CERTIFICATE OF VOTE

2016-SGD-01

RE: REVISED 1-24-20 ONE BOSTON WAY- DESCRIPTION AND CLARIFICATION OF REQUESTED MINOR MODIFICATIONS IN COORDINATION WITH 3 BOSTON WAY.

On behalf of the Applicant for One Boston Way, GSD Associates, LLC is submitting the following summary of revisions and clarifications to the site and façade designs for the requested minor modifications as described below. The modifications are described in **bold**.

NEW 1 BOSTON WAY SITE PLAN, SHOWING THE PEDESTRIAN PATHWAYS BETWEEN THE TWO BUILDINGS

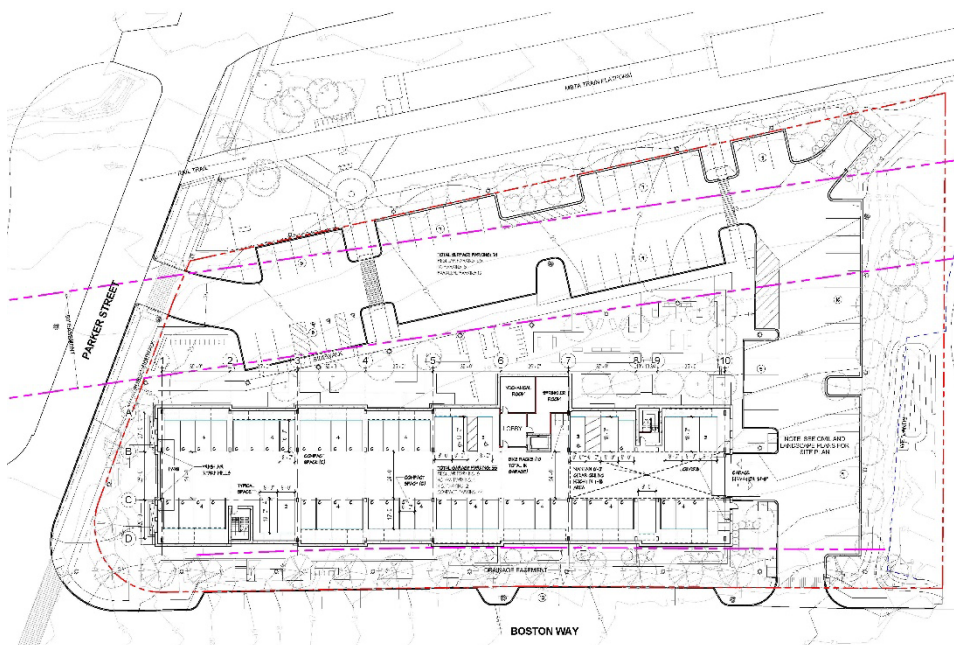
The parking and driveway at 1 Boston way and 3 Boston Way are proposed to be used as described below. To do this we will require Minor Modifications to the 1 Boston Way Site Plan.

- We are proposing a Reciprocal Easement Agreement (REA) to allow for traffic from 3 Boston Way to travel through One Boston Way to access Parker Street and to create two pedestrian paths between the 1 Boston Way and 3 Boston Way sites. Please see the approved and the new plans below and attached for comparison.
- The sewer, water, lighting, trash and other utilities will be extended and coordinated during the sitework for 3 Boston Way in accordance with the proposed REA.
